ADDENDUM

ADDENDUM NO.: 01
PROJECT NAME: Sheridan Elementary School Annex
PROJECT NO.: 05075
CONTRACT NO.: C1581
DATE OF ISSUE: September 1, 2017

NOTICE OF CHANGES, MODIFICATIONS, OR CLARIFICATIONS TO CONTRACT DOCUMENTS

06 ELEVATOR PIT LADDER SCALE: 1/2\"/>

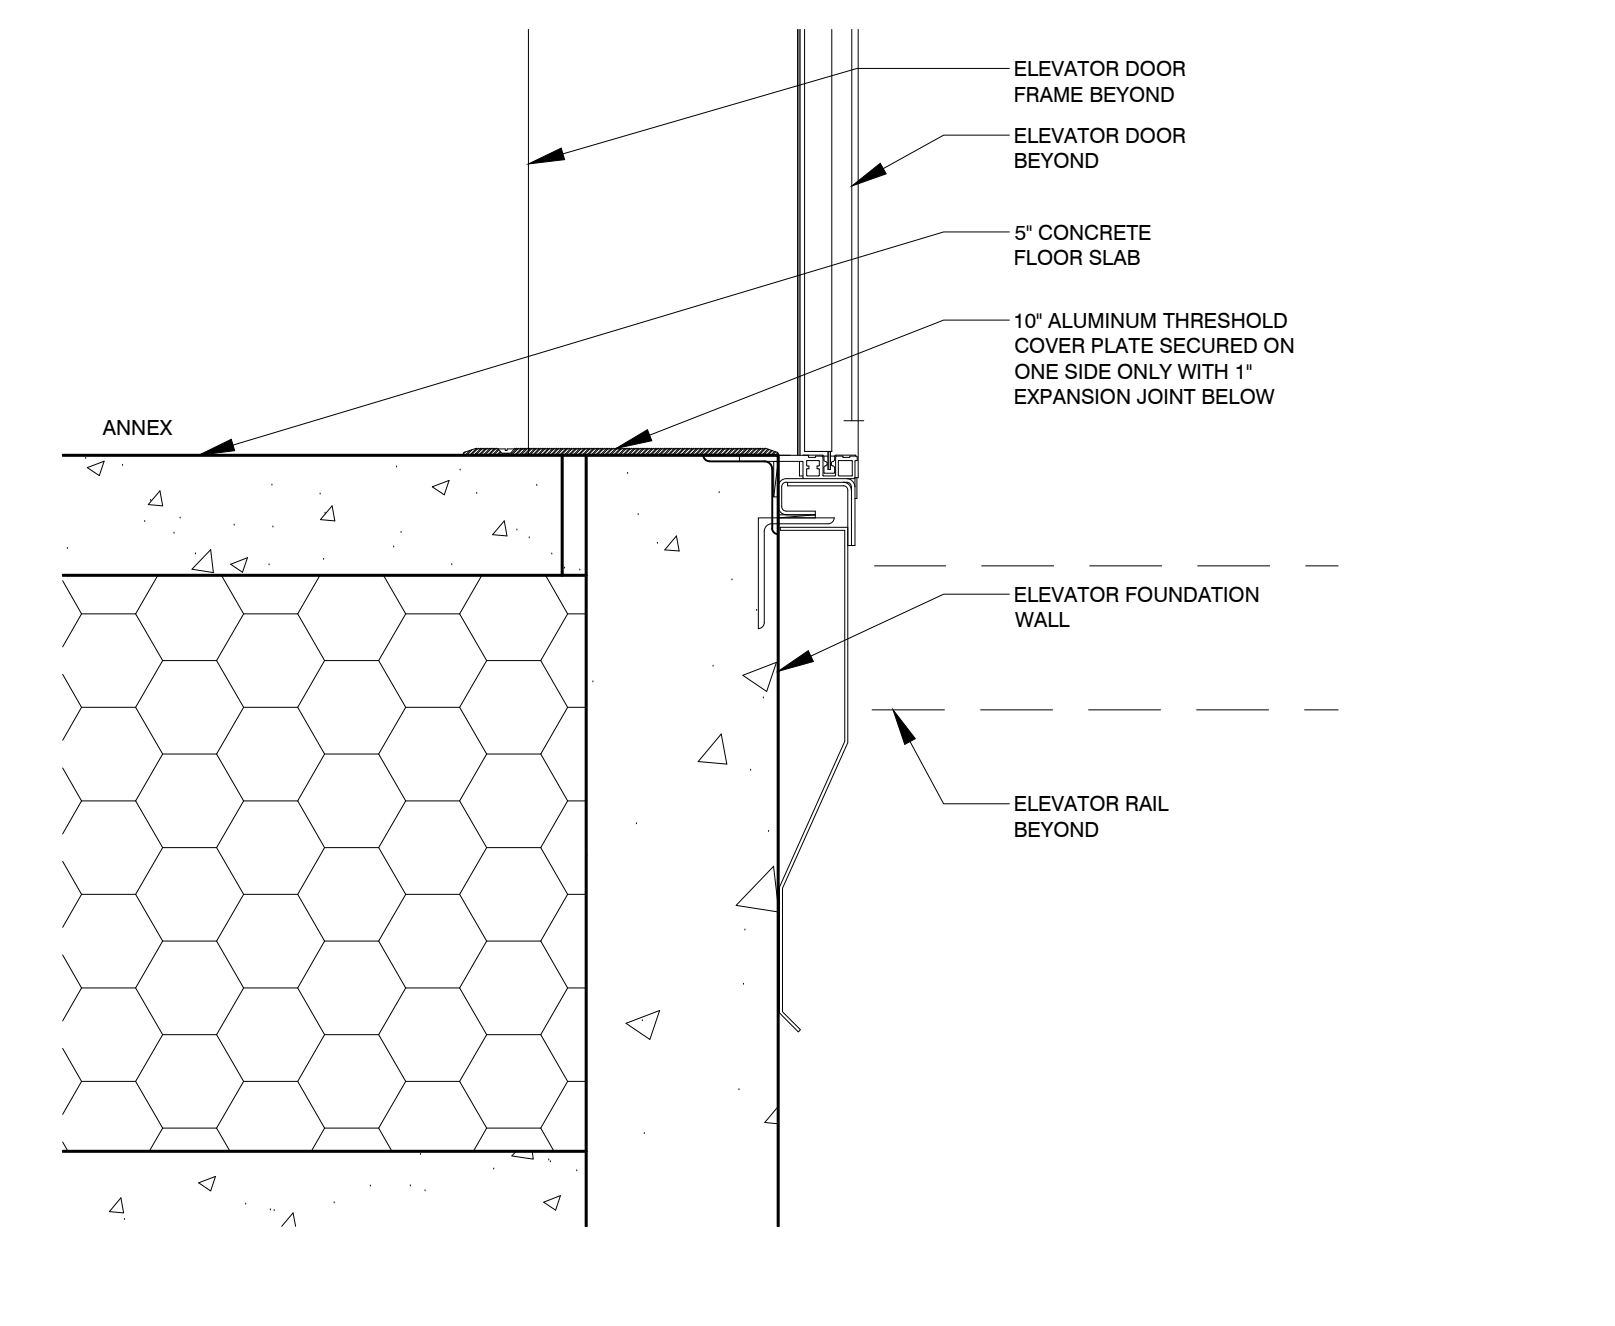
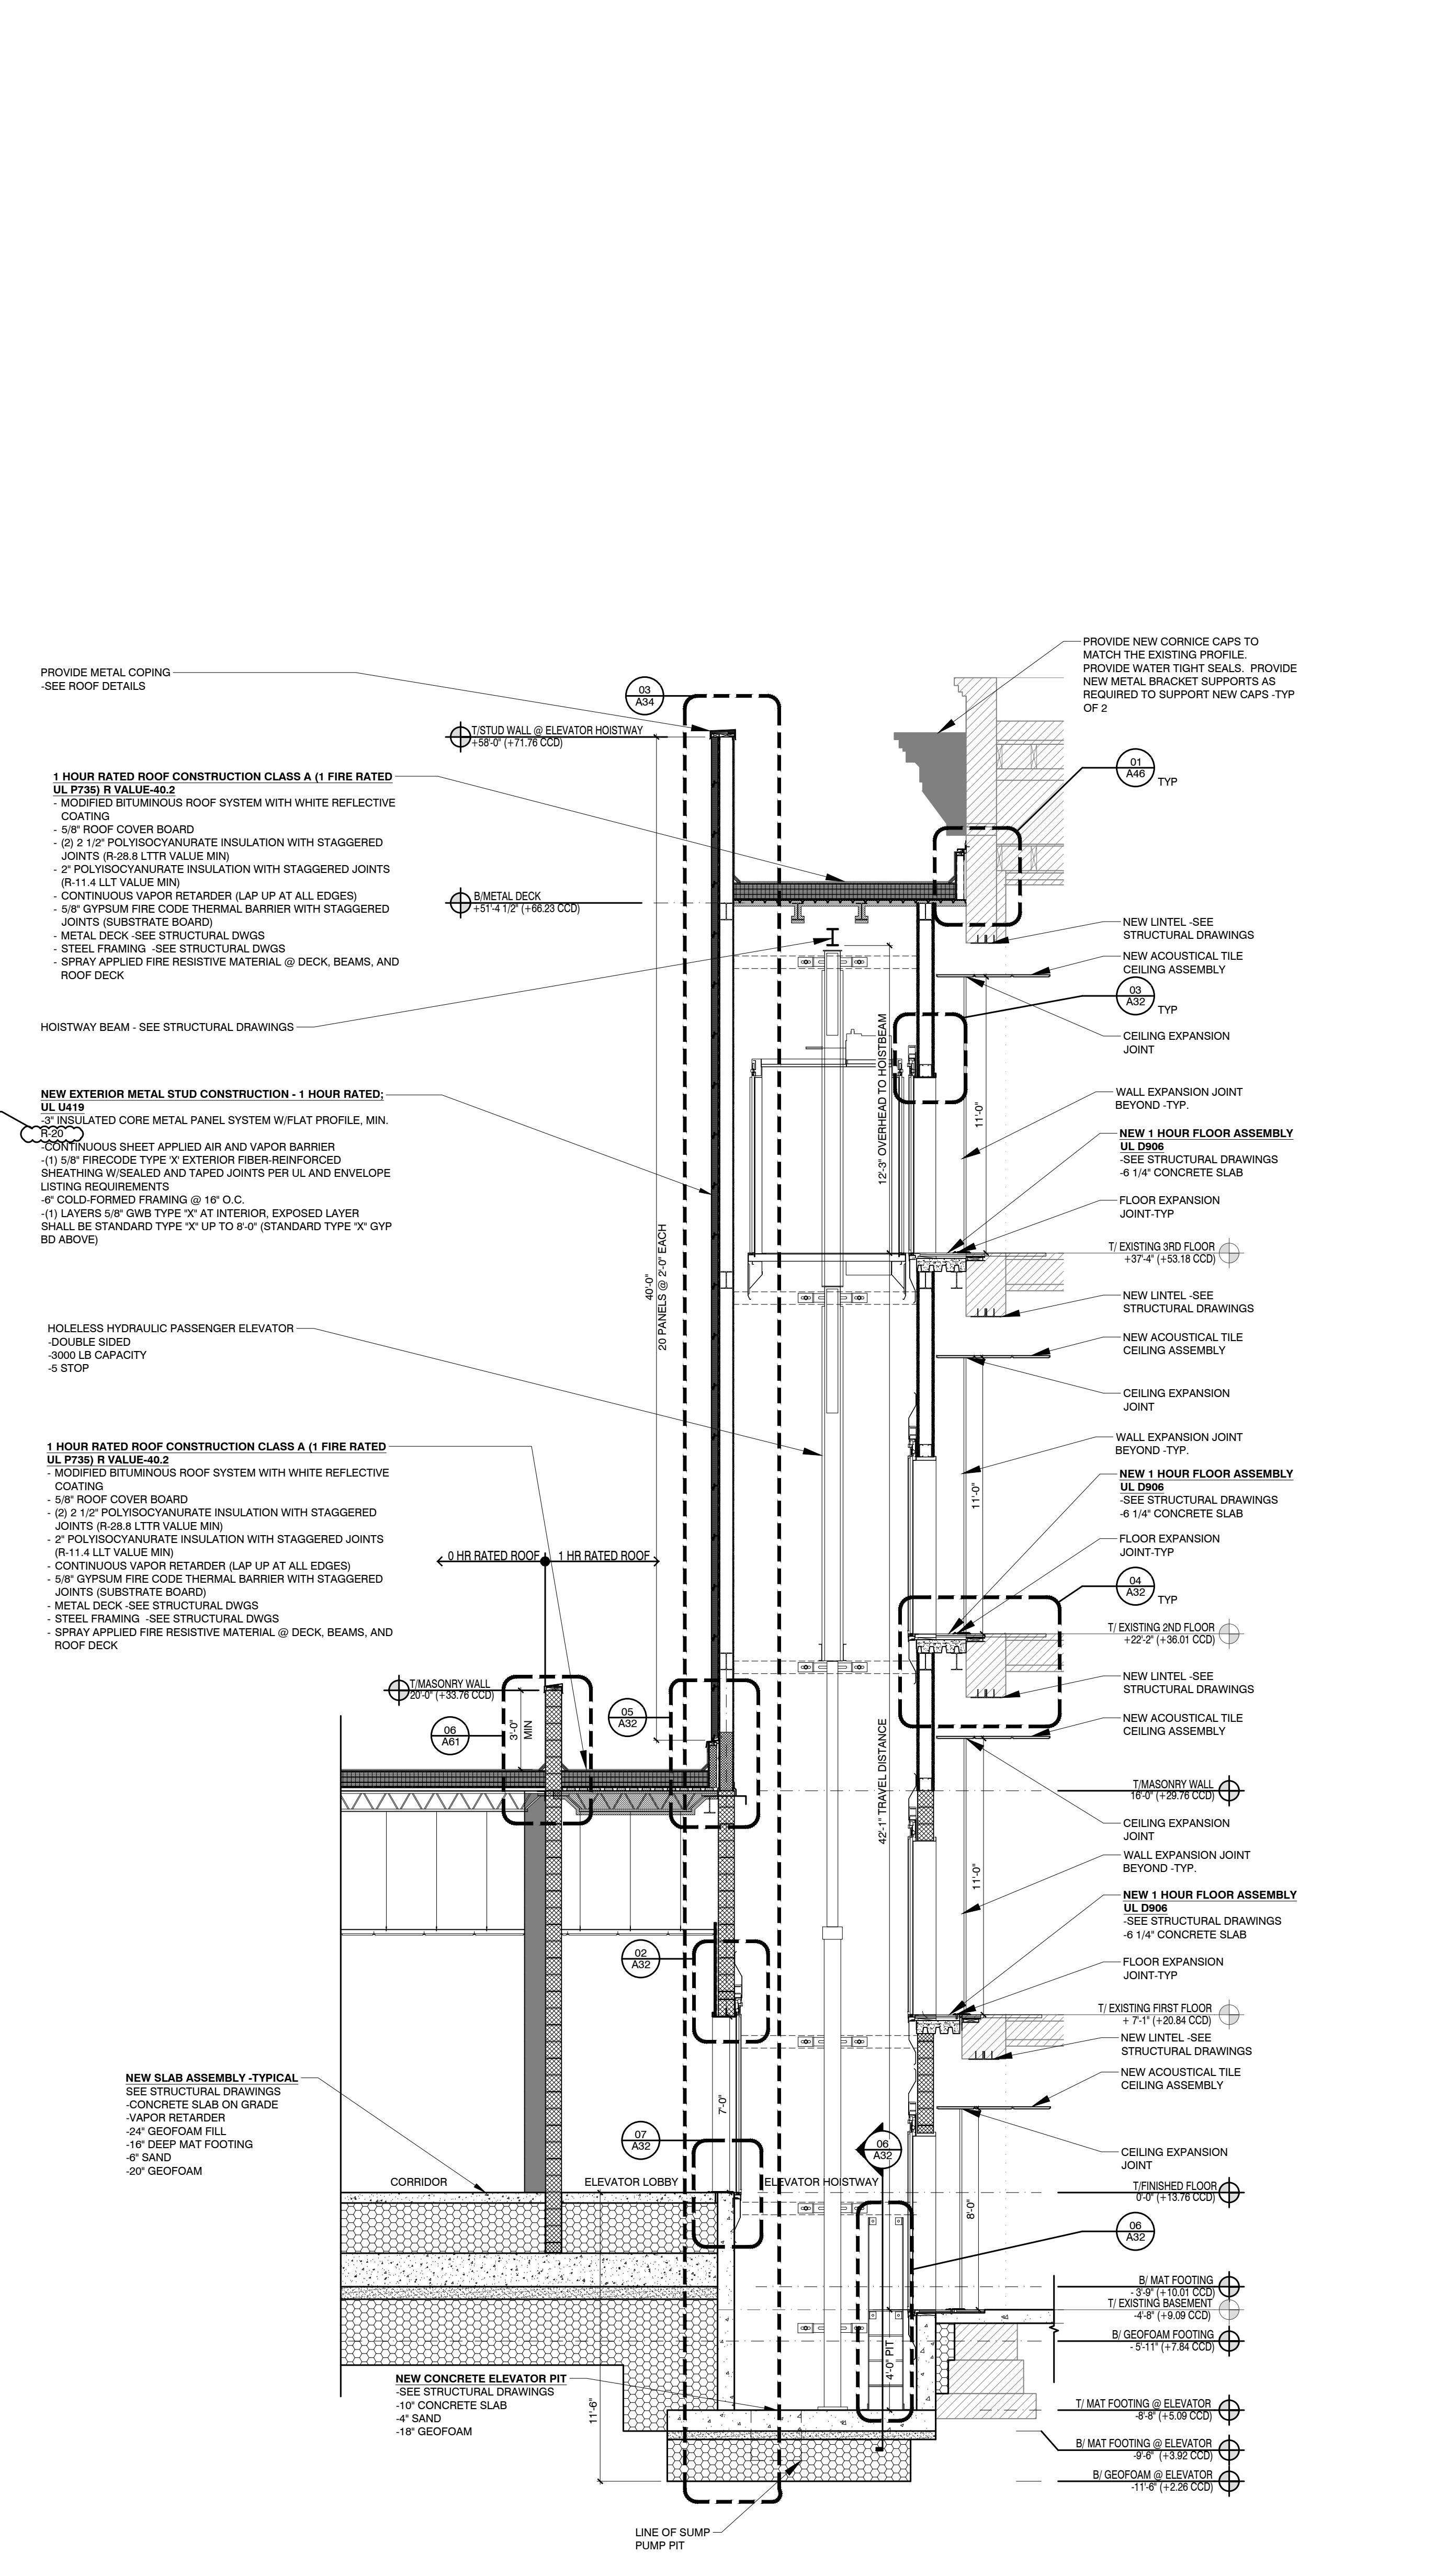
- Change 7. REVISED** – Drawing No. A32 – ELEVATOR SECTION & ELEVATOR DETAILS: Increased R value of insulated metal panels at elevator to R-20
- Change 8. REVISED** – Drawing No. A34 – WALL SECTIONS: Increased R value of insulated metal panels at elevator to R-20
